# UNITED STATES PATENT AND TRADEMARK OFFICE

APPLICATION NO.	FILING DATE	FIRST NAMED INVENTOR	ATTORNEY DOCKET NO.	CONFIRMATION NO.
10/617,598	07/11/2003	Dean L. Kamen	1062/D77	2911
2101	7590	10/07/2004	EXAMINER	
BROMBERG & SUNSTEIN LLP 125 SUMMER STREET BOSTON, MA 02110-1618			ROYAL, PAUL	
			ART UNIT	PAPER NUMBER

<b>Office Action Summary</b>	<b>Application No.</b> 10/617,598	<b>Applicant(s)</b> KAMEN ET AL.	
	<b>Examiner</b> Paul Royal	<b>Art Unit</b> 3611

## **DETAILED ACTION**

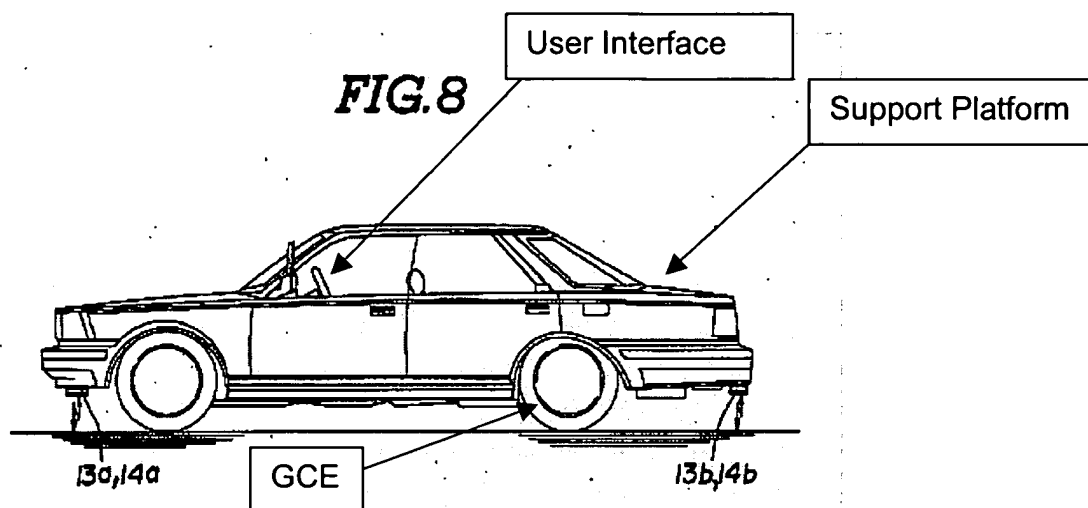
Kishi et al. teaches a vehicle including a pitch/roll sensor system comprising:  
a support platform (Support Platform, see Examiner's annotated Figure 8 ) for supporting the load, the support platform characterized by a fore-aft axis, a lateral axis, and an orientation with respect to the surface, the orientation referred to as an attitude;  
at least one ground-contacting element (GCE, see Examiner's annotated Figure 8) coupled to the support platform in such a manner that the attitude of the support platform is capable of variation;  
a sensor module (13a,13b,14a, 14b) for generating a signal characterizing the attitude of the support platform; and

a controller (20) for commanding the motorized drive arrangement based at least on the attitude of the support platform or based on a position of a center of mass of the load relative to the at least one ground-contacting element,

a user interface (User Interface, see Examiner's annotated Figure 8), wherein the attitude of the support platform is capable of variation based on a signal generated by the user interface, wherein the controller commands motion in the fore-aft and lateral planes, such as pitching and rolling generated by turning the vehicle via the user interface.
